# REQUEST FOR INFORMATION (RFI)

RFI No.: ABF-RFI-003155R00 Submitted By: \_\_\_\_\_ Pages: 3  
 RFI Date: 07-January-2013 Contact Name: Osullivan, Bill Phone No. 510-808-4602  
 Pages Attached: 2

<b>Subject: Electrical Layout: Piers</b>	
<b>References:</b>	
<b>Sub/Sup: BLI</b>	<b>Sub RFI #: RFI-BLI-000166R00</b>
<b>Response Required by: 14-January-2013</b>	<b>Response affects critical path activity?</b>

**To:** Caltrans  
**Attn:** Bill Shedd, Martin Chandrawinata, Stanley Ku  
**Project:** 04-0120F4 - SAS  
**RFI Date:** 1/7/2013  
**RFI No:** 3155R00  
**Subject:** **Electrical Layouts: Piers**

RFI 3155 Sketch  
Reference Sheet E-264C

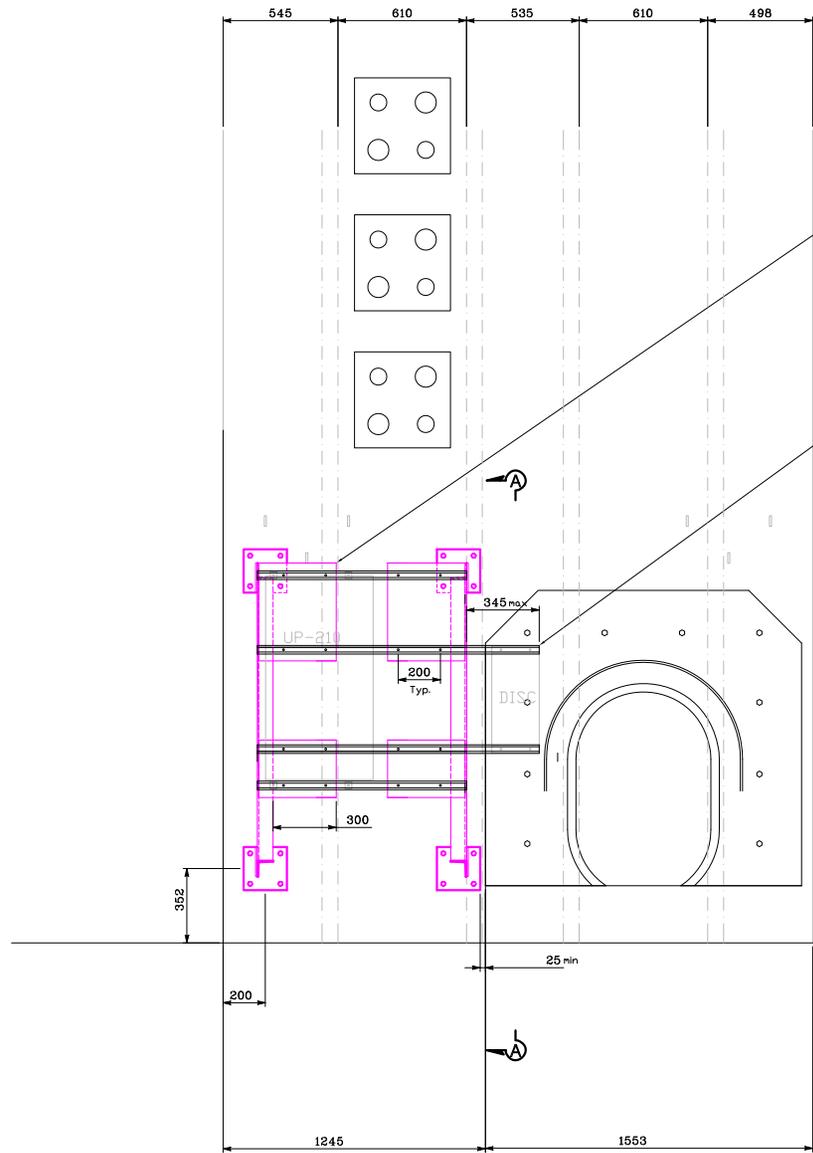
Two of the four base plates for the UP-210 mounting structure are on the access door doubler plate, resulting in an unlevel structure. Additionally the base plates may coincide with the bolts and/or cowling plate and may interfere with access door opening although equipment is held 305 from the face of the skin plate. Please advise.

Rack at Elevation 53.85 for UP-210 and Disconnect, as designed and approved in Submittal 2744R0, interferes with doubler plate.

Please modify the rack and attach unistruts per the attached sketch. Galvanized surface repairs shall be performed per section 75 of the standard specifications

Split rack by cutting plates, trim plates to 300mm from edge of L76x76. Repair finish of cut edges using approved method. Mount in locations shown.

41 Unistrut, HDG. Mount each piece with min two 13mm dia. bolts on each side of rack, min 200mm spacing. Cantilever as needed to mount circuit breaker, up to 345mm, to provide adequate spacing for conduit routing.

Modify rack and attach unistrut as shown in the attached drawing. Repair galvanized finish using approved method.
